Proposed Waitaha Hydro Scheme

PEER REVIEW

**APPLICANT'S ASSESSMENT OF NATURAL CHARACTER,
LANDSCAPE AND VISUAL AMENITY EFFECTS**

April 2015

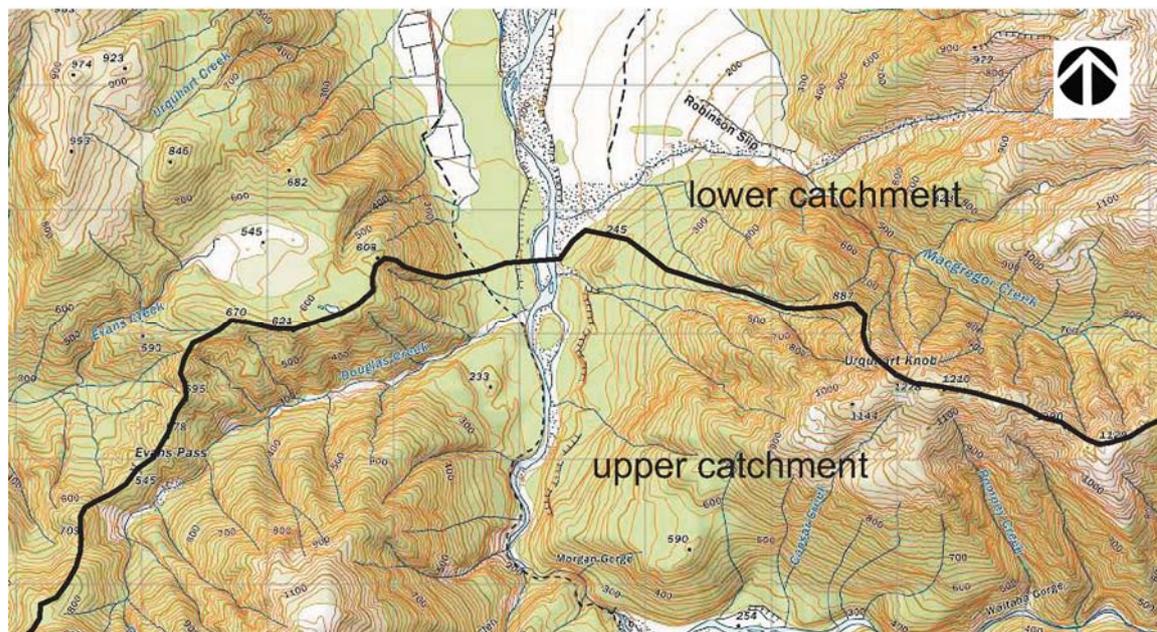
An issue raised in the Isthmus review argues that the line of demarcation between the upper and lower catchments could be mapped differently. Put simply, the upper catchment including the gorge is found by both Messrs. Lister and Bentley as likely to meet the requirements of an ONL, while the lower catchment is by contrast settled and farmed, and therefore less natural. The range pierced by the Morgan Gorge at a broad landscape scale provides the division between the two catchments and resulting different landscape character areas.

The Isthmus report suggests that the mapped line of change could be moved closer to the proposed powerstation site which infers that the more enclosed gorge

topography might be a better change point. However Mr Bentley has re-examined his assessment of this line and has decided to retain it as is⁴. I agree with Mr Bentley's opinion and I favour his more conservative approach. The landscape

around the power station site is more open and easier to traverse and is less sublime than the chasm-like gorge - however it remains undeveloped, is located adjacent to a steep terrace scarp, and the general area remains clothed in indigenous cover and is out of view of the settled plains to the north.

Perhaps a third option for locating a catchment demarcation line would be to consider the Macgregor Creek sub-catchment as forming the boundary which would be topographically easy to define, and would still be close to Mr Bentley's Urquhart Knob spur division line (see diagram above).
